DEPARTMENT OF THE ARMY
NEW ORLEANS DISTRICT, CORPS OF ENGINEERS
P.O. BOX 60267
NEW ORLEANS, LOUISIANA 70160-0267

SUBJECT: MVN 2010-1041 WB
General Permit NOD-20

Receipt is acknowledged of your letter dated May 20, 2010, requesting authority to install HESCO Baskets being placed along sections of beach situated between Fourcheon and Grand Isle area in Lafourche/Jefferson Parishes to prevent oil encroachment into interior marshes that resulted from the BP Oil spill Deepwater Horizon.

Proposed HESCO Basket Placement Area

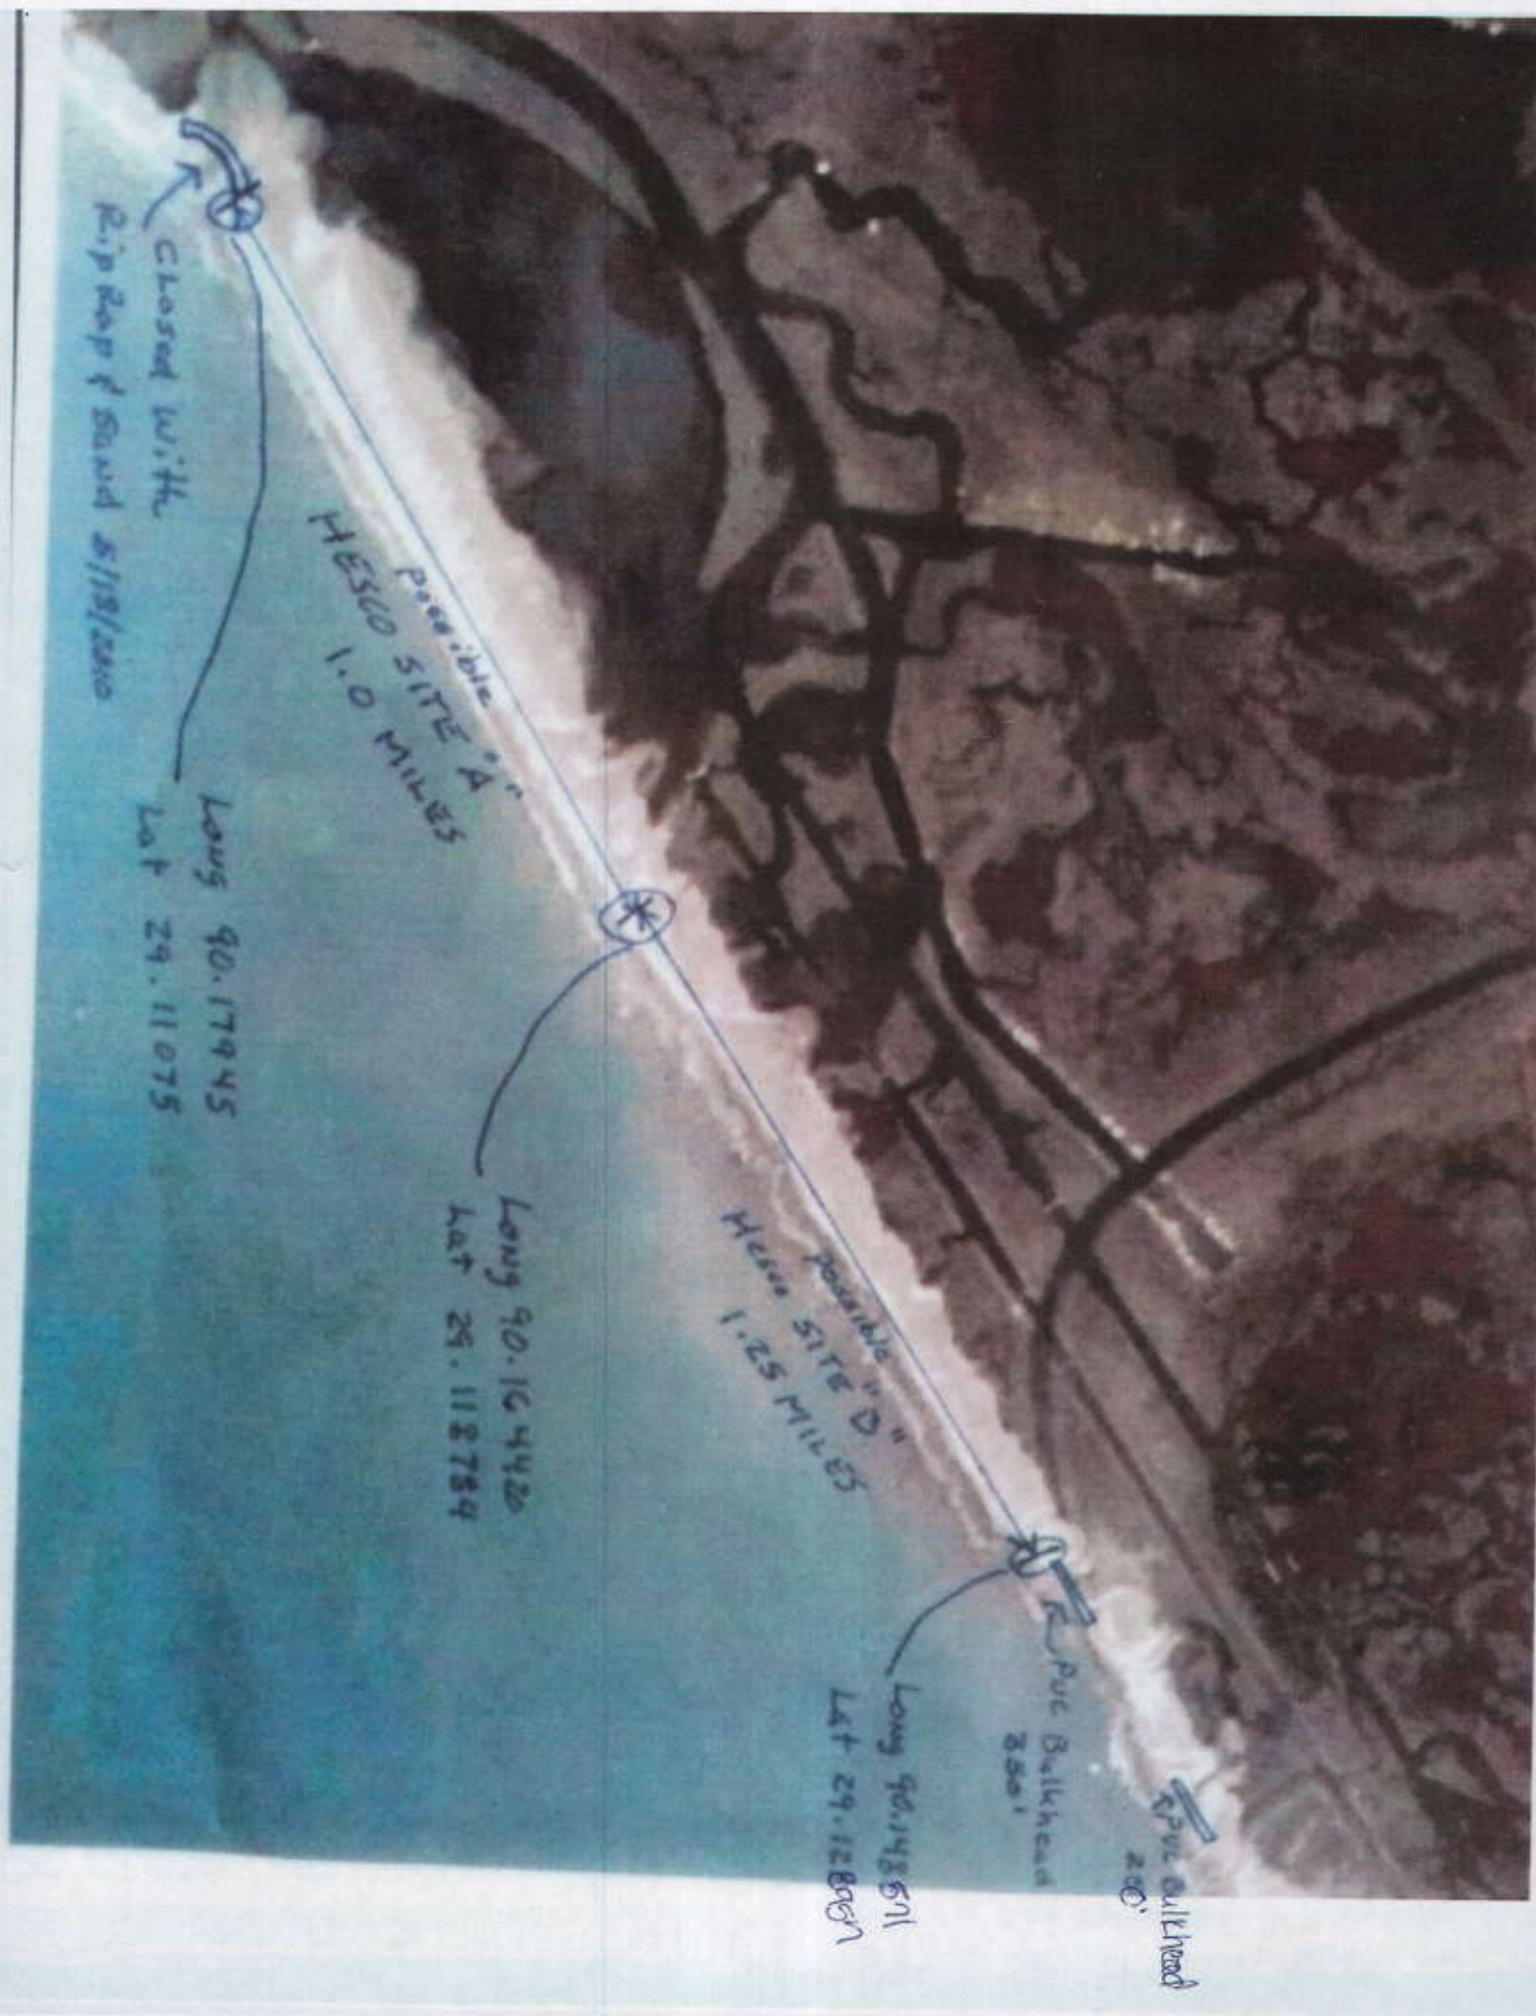
All construction activities should be temporary in nature and conducted on the gulfside of the baskets and the area landward of the HESCO baskets should be designated as a no-work zone.

All vehicular traffic should prohibited landward of the HESCO baskets.
